Access Compliance Report

Public Rights-of-Way

(Curb Ramps)

Intersection ID: 45064	Main Street: CHALKSTONE_RD	Cross Street: ESCAFLWNE_AV	Location: NE
ADA ID: 8625001ABB6E	Ramp Type: BlendTrans1	Initial Pass/Fail: Fail	Overall Compliance: No
		Severity Score: 8.75

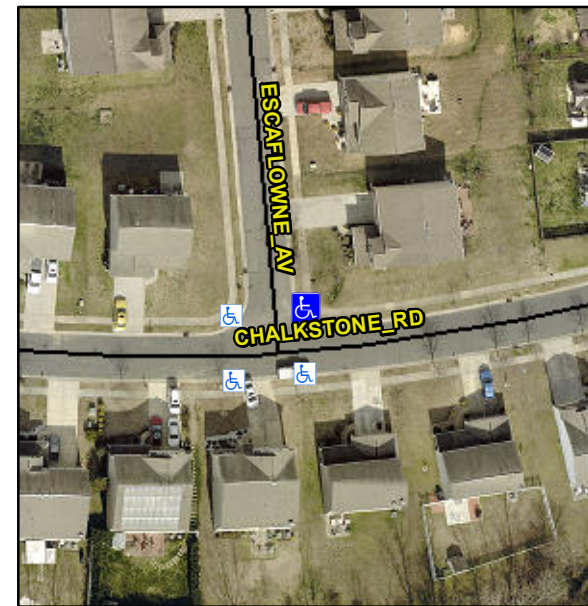
Not Found, R304.5.1

Compliance	Description	Data	Compliance	Description	Data
N/A	Ramp Length (in)	47.0	Yes	BlendTrans Slope (%)	4.5
No	Ramp Width (in)	41.0	Yes	BlendTrans XSlope (%)	1.0
N/A	Flare Type LT	N/A	N/A	Flare Type RT	N/A
N/A	Flare Slope LT (%)	N/A	N/A	Flare Slope RT (%)	N/A
N/A	Flare Traversable LT?	N/A	N/A	Flare Traversable RT?	N/A
N/A	Landing Length (in)	N/A	N/A	DWS Provided?	N/A
N/A	Landing Width (in)	N/A	N/A	DWS Contrast?	N/A
N/A	Landing Slope (%)	N/A	N/A	DWS Length (in)	N/A
N/A	Landing X Slope (%)	N/A	N/A	DWS Full Width?	N/A
N/A	Landing Curb? (Y/N)	N/A	N/A	DWS Offset (in)	N/A
N/A	Shared Landing?	N/A			
N/A	Gutter Ponding?	N/A	N/A	Gutter Slope (%)	N/A
N/A	Gutter Lip Ht (in)	N/A	N/A	Gutter X Slope (%)	N/A
N/A	Painted X Walk1?	No	N/A	Painted X Walk2?	No
	X Walk 1 Direction	To W		X Walk 2 Direction	To S
	X Walk 1 Width (in)	N/A		X Walk 2 Width (in)	N/A
	X Walk 1 Slope (%)	0.1		X Walk 2 Slope (%)	4.3
	X Walk 1 X Slope (%)	0.3		X Walk 2 X Slope (%)	0.4

N/A	Ramp inside XWalk1?	N/A	N/A	Ramp inside XWalk2?	N/A
	Road Slope (%)	0.7		Clear Space?	N/A
	Road X Slope (%)	0.5	N/A	Clear Space to XWalk (in)	N/A
N/A	Any Obstructions?	N/A	N/A	Storm Grate/Utility Hazard?	N/A
	Obstruction Type			Storm Grate/Utility Type	
		N/A			N/A
			Yes	Surface Condition? (G/P)	Good
			No	Curb Slope (%)	8.5

Remove & Replace Curb Ramp With Two New Directional Ramps or Equivalent.
